Fast Fault Current Injection GC0111

Antony Johnson
National Grid
January 2019

Comments received following updated text in January 2019

Reactive Current / Voltage curve – Parameters (2)

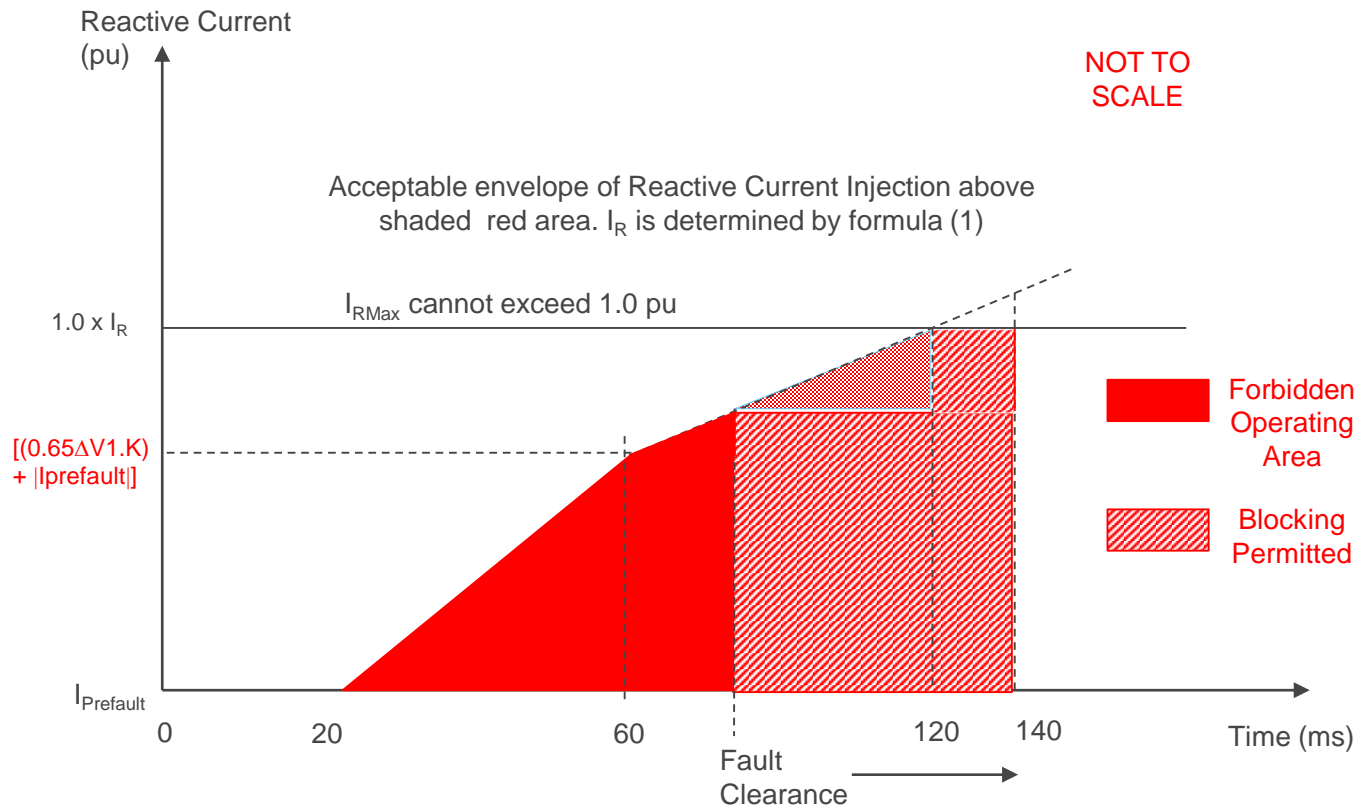
~~V_{prefault} – Is the Prefault Positive Phase Sequence RMS voltage in per unit~~

~~$V_{\text{insensitivity}}$ – Is the difference in magnitude between the pre-fault voltage and the minimum continuous operating voltage as defined in ECC.6.1.4 (ie $V_{\text{prefault}} - 0.9$) – Default setting 0.1 unless otherwise agreed.~~

$$\Delta V_1 = 0.9 - V_{\text{retained}}$$

V_{retained} – Is the retained positive sequence voltage at the Grid Entry Point or User System Entry Point (under fault conditions)

k – Is the gain factor (range proposed 2 – 7) – Default setting 2.5

FFCI Figure ECC.16.3.16(b)

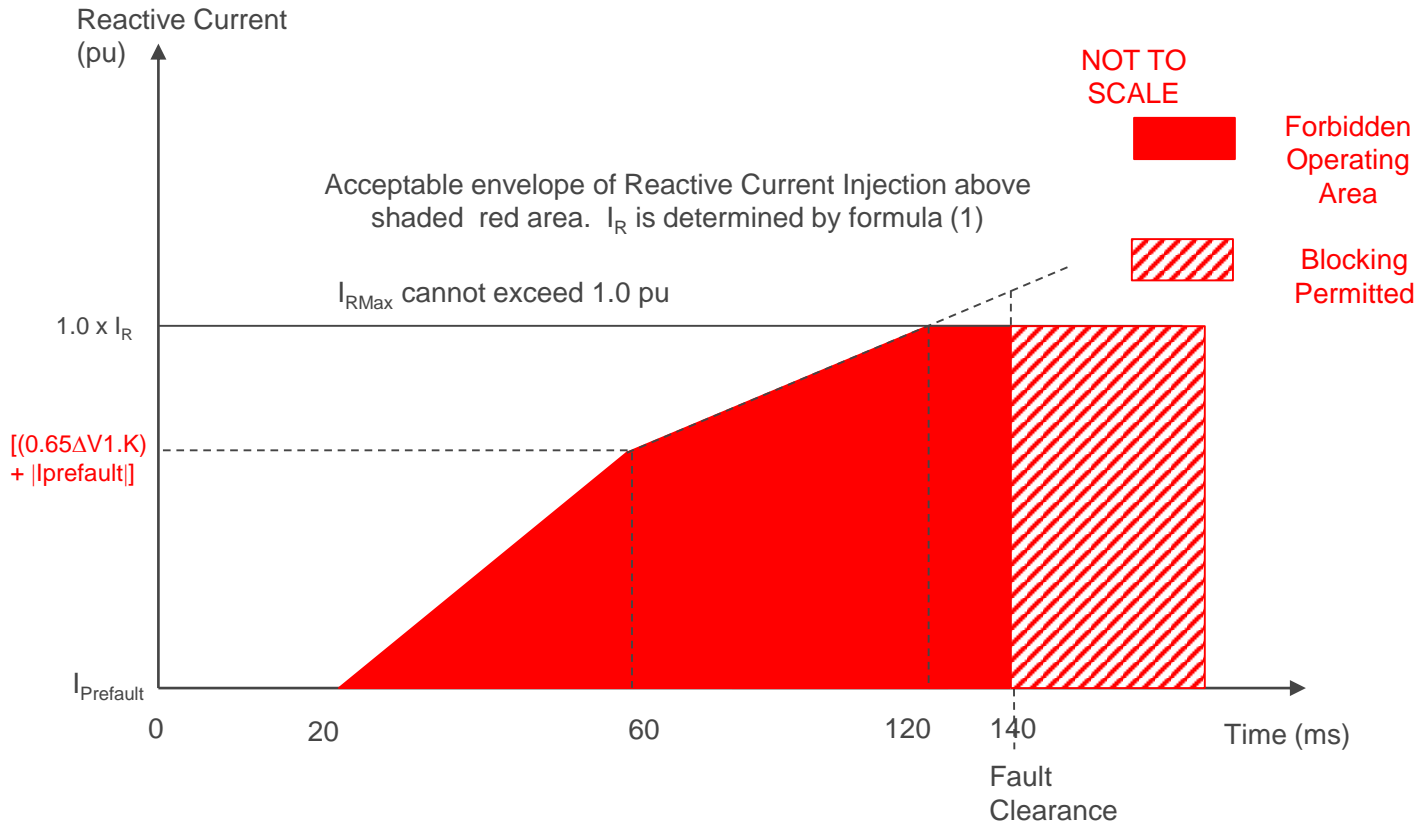
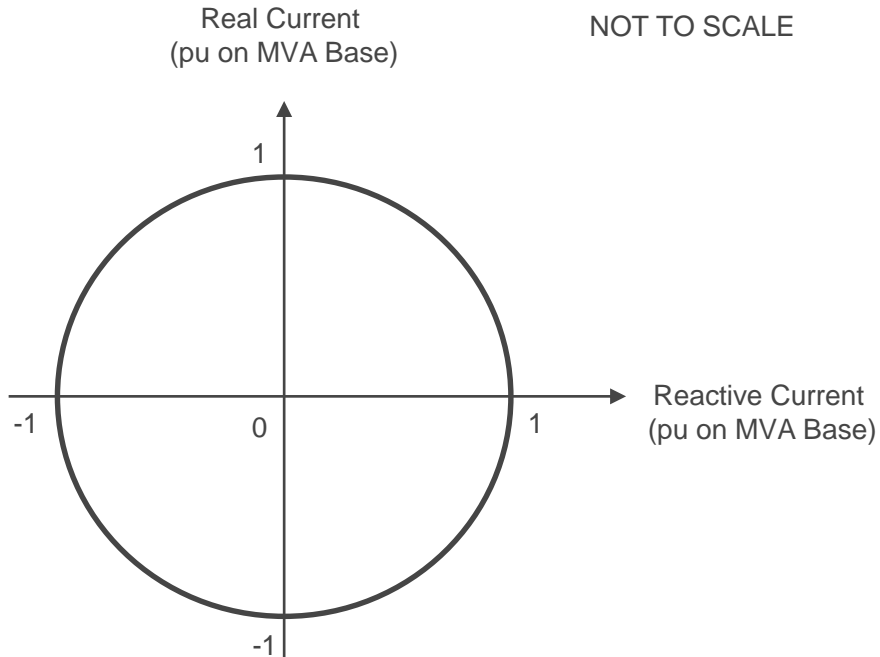
I_{RMAX} – The maximum current which shall, as a minimum, be above the shaded areas defined by Figures ECC.16.3.16(b) or ECC.16.3.16(c). There is no requirement for the maximum supplied current to exceed 1.0pu.

Active / Reactive Current Circle Diagram (FFCI Figure ECC.16.3.16(d))

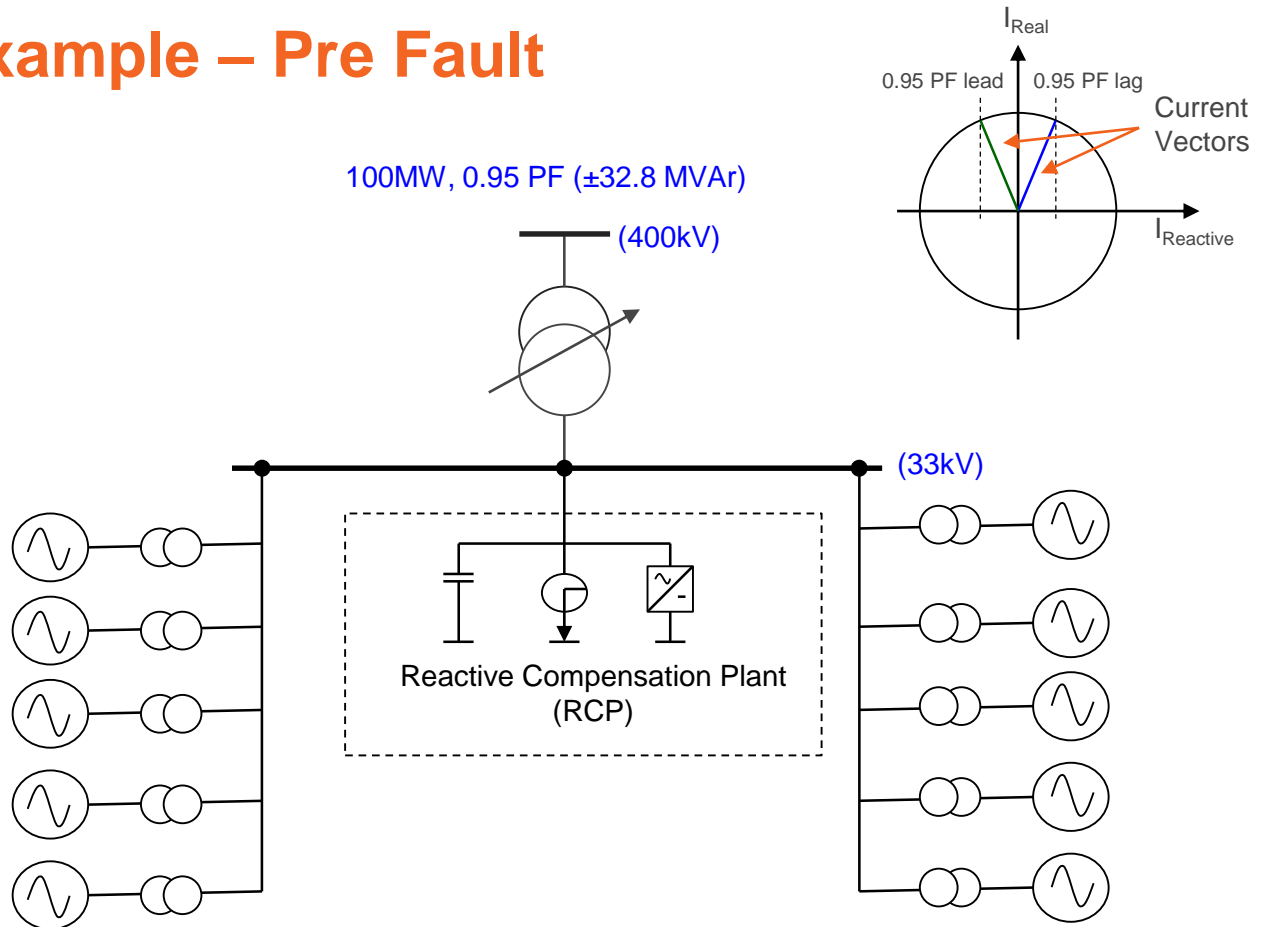
NOTE:- 1 pu current is the rated current of the Power Park Module or HVDC Equipment when operating at full MW output and full leading or Lagging MVar capability (eg for a 100MW Power Park Module Rated Current would be obtained when the Power Park Module is supplying 100MW and 0.95 Power Factor lead or 0.95 Power Factor lag at the Connection Point). **Note this is the rating of the converter. When I_R is less than 1.0 pu any residual reactive current should be supplied as Active Current**

Why is Voltage Control Relevant for Fast Fault Current Injection (2)

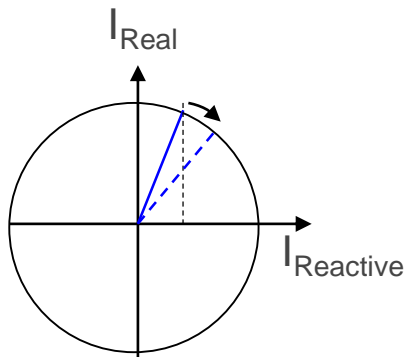
- In summary under pre-fault conditions with the Power Park Module operating at full leading conditions or full lagging conditions at Rated MW output it will be operating at rated current and therefore the additional current supplied will be limited under fault conditions.
- NOTE – With priority given to reactive current - under a voltage dip condition the vector will start to move along the locus resulting in an increase in the reactive current

Example 1 - FFCI Figure ECC.16.3.16(b)

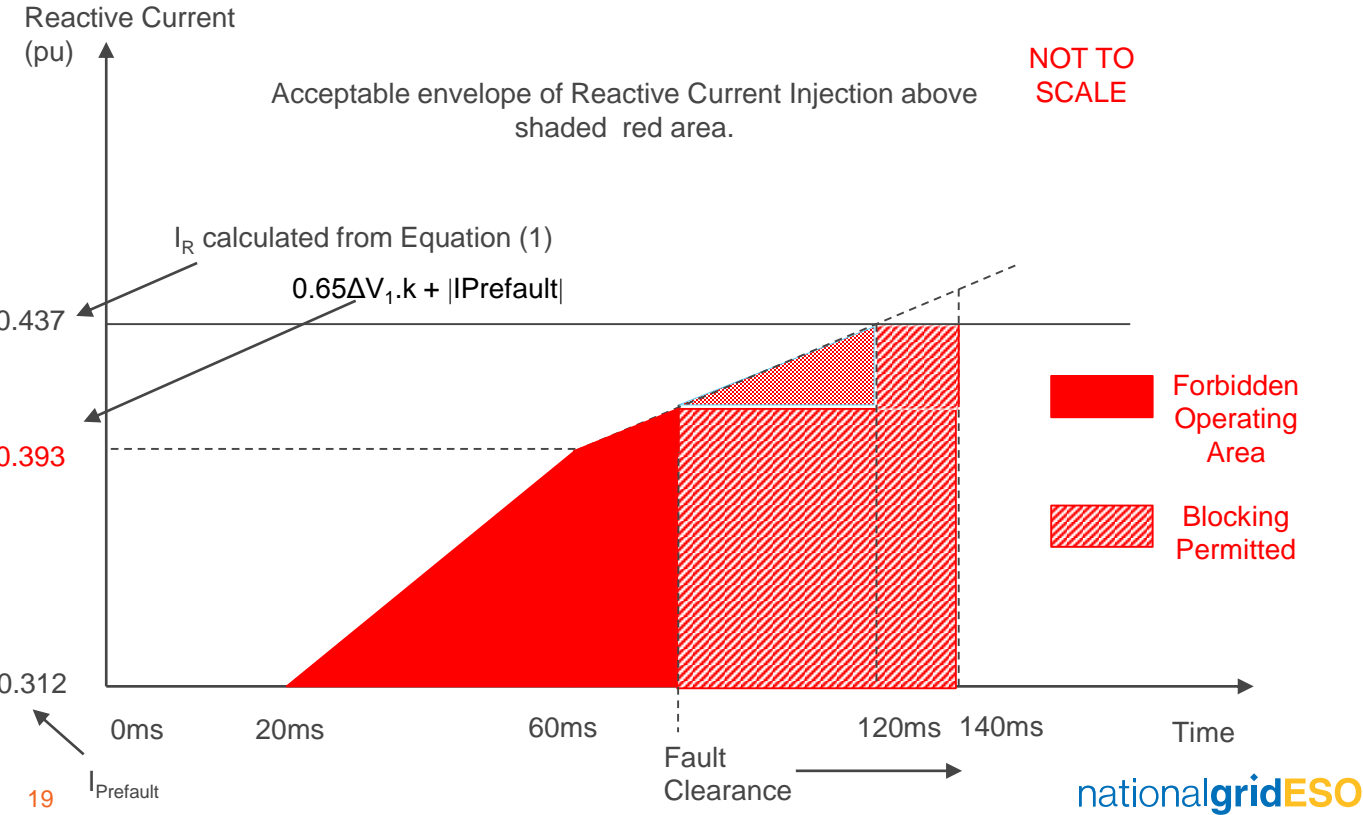
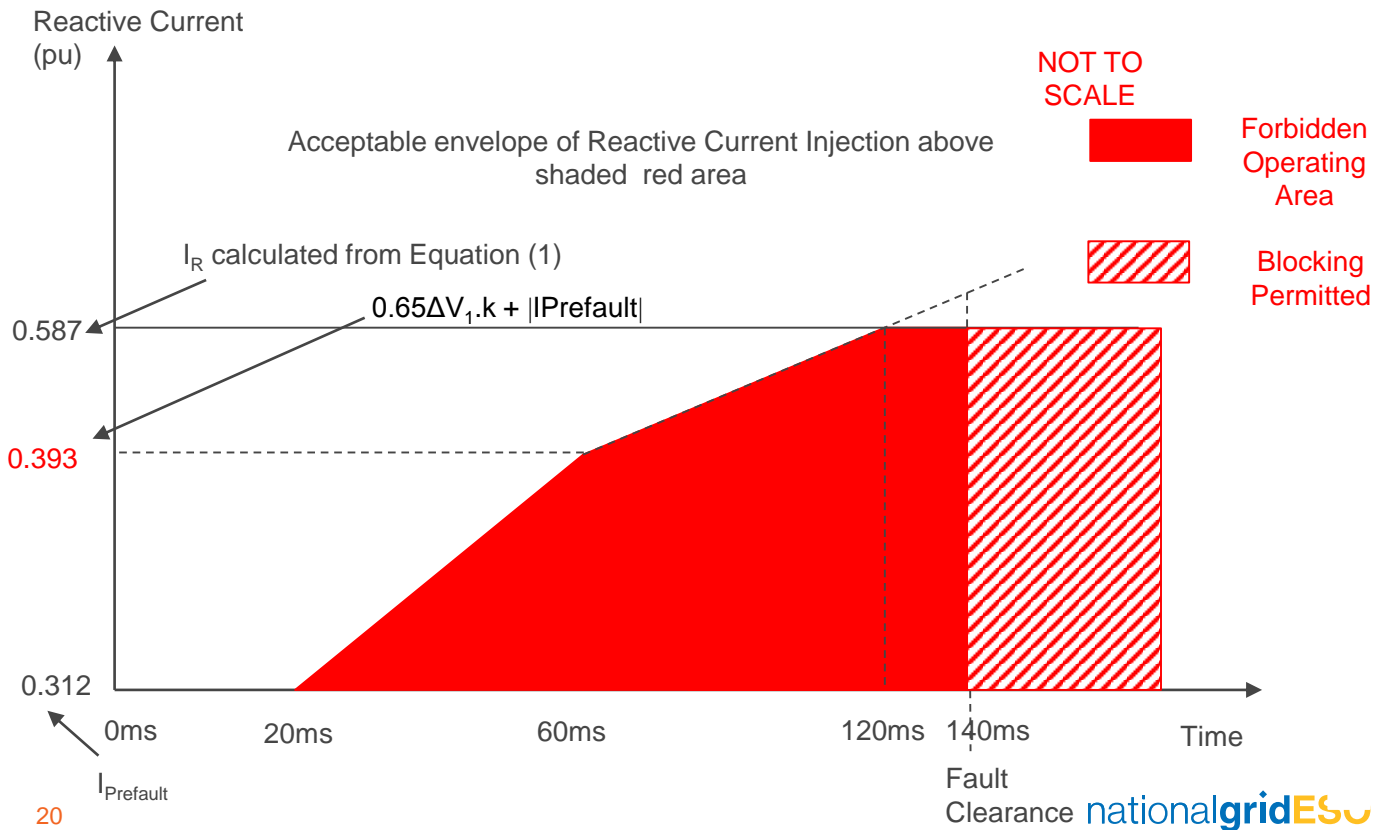
Example 1 – Power Park Module (Slide 10) operating at full MW output and full MVar lag – volt drop to 85% and K = 2.5

- Wind farm is operating at 100MW output and 0.95 PF lagging (ie 32.8MVar or export to the System)
- $I_R = \Delta V_1 \cdot k + |I_{\text{prefault}}|$
- And $\Delta V_1 = 0.9 - V_{\text{retained}}$
- If V Prefault = 0.96 pu and Q max = 0.95 PF lag on a 4% droop
- In this case the retained voltage (V_{retained}) is 0.85 pu
- $\Delta V_1 = 0.9 - V_{\text{retained}} = 0.9 - 0.85 = 0.05$
- $I_{\text{prefault}} = \sin(\arccos 0.95) = 0.312 \text{ pu}$
- $I_R = \Delta V_1 \cdot k + |I_{\text{prefault}}| = 0.05 \times 2.5 + 0.312 = 0.437 \text{ pu}$
- $I_R = (0.65 \Delta V_1 \cdot k) + |I_{\text{prefault}}| = (0.65 \times 0.05 \times 2.5) + 0.312 = 0.3933$

Example 3 - FFCI Figure ECC.16.3.16(b)

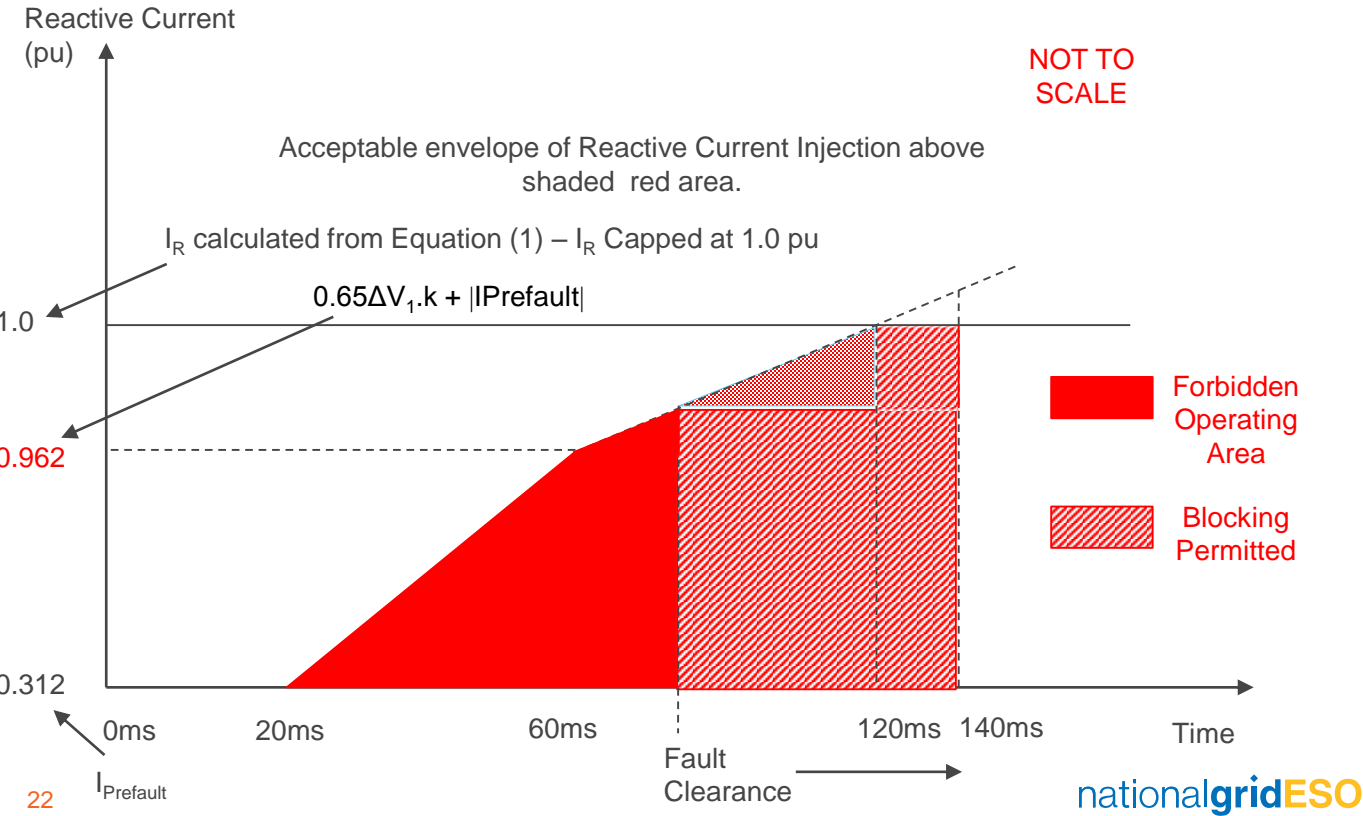
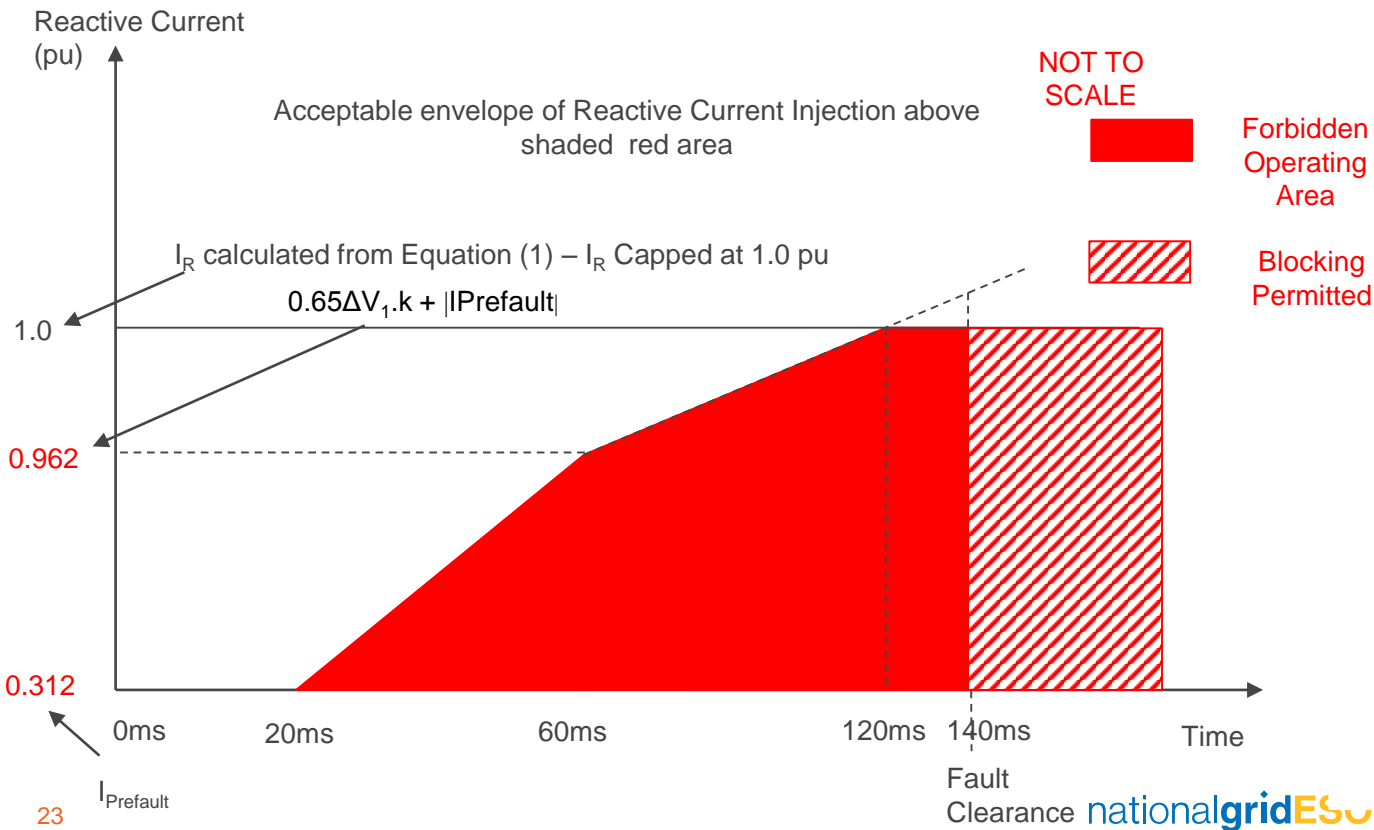
Example 3 – Power Park Module (Slide 11) operating at full MW output and full MVAr output – volt drop to 50% and $K = 2.5$

- Wind farm is operating at 100MW output and 0.95 PF lagging (ie 32.8MVAr or export to the System)
- $I_R = \Delta V_1 \cdot k + |I_{\text{Prefault}}|$
- And $\Delta V_1 = 0.9 - V_{\text{retained}}$
- If $V_{\text{Prefault}} = 0.96 \text{ p.u}$ and $Q_{\text{max}} = 0.95 \text{ PF lag}$ on a 4% droop
- In this case the retained voltage (V_{retained}) is 0.5 pu
- $\Delta V_1 = 0.9 - V_{\text{retained}} = 0.9 - 0.5 = 0.4$
- $I_{\text{prefault}} = \sin(\arccos 0.95) = 0.312 \text{ pu}$
- $I_R = \Delta V_1 \cdot k + |I_{\text{Prefault}}| = 0.4 \times 2.5 + 0.312 = 1.312 \text{ pu}$ – capped at 1.0pu reactive current
- $I_R = (0.65 \Delta V_1 \cdot k) + |I_{\text{prefault}}| = (0.65 \times 0.4 \times 2.5) + 0.312 = 0.962 \text{ pu}$
